**KANE PACKAGE PHILIPPINE INC.**

INVESTIGATION REPORT FORM (IRF)

Customer	BROTHER INDUSTRIES PHILIPPINES, INC.	Attention To	REXEL ALMARIO
Item Code	D02Y4T001	Department	PRODUCTION
Item Description	PRINTED CARTON E115B CHN	Date of Detection	250318
Job Order Number	JO25-M-00781-66	Section Detected	QA SCREENING

ILLUSTRATION OF THE PROBLEM

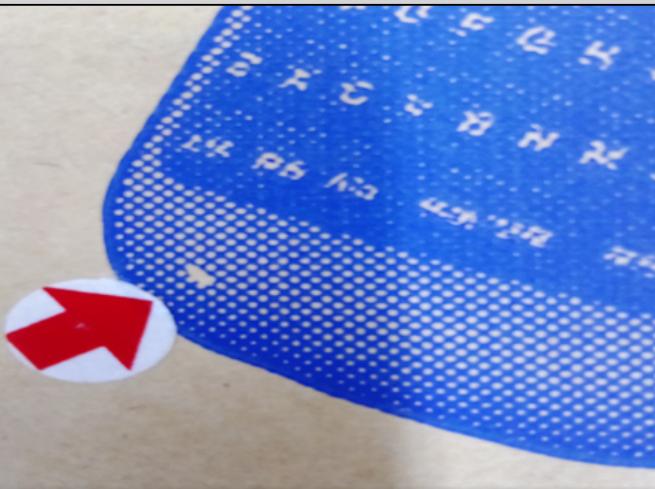
SPOT(S)

Spot is not acceptable

Spot on printer image

WHY 1 : Uneven distribution of ink to the substrate.

WHY 2 : There is blockage of anilox.

WHY 3 : Foreign materials stick in the flexo plate.

WHY 1: Inclusion of Rubber Dust Remover usage in Eqos daily Parameter sheet to monitor if the operator use it for the items with single mylar in printing unit 2. Production IE // 2025-06-14
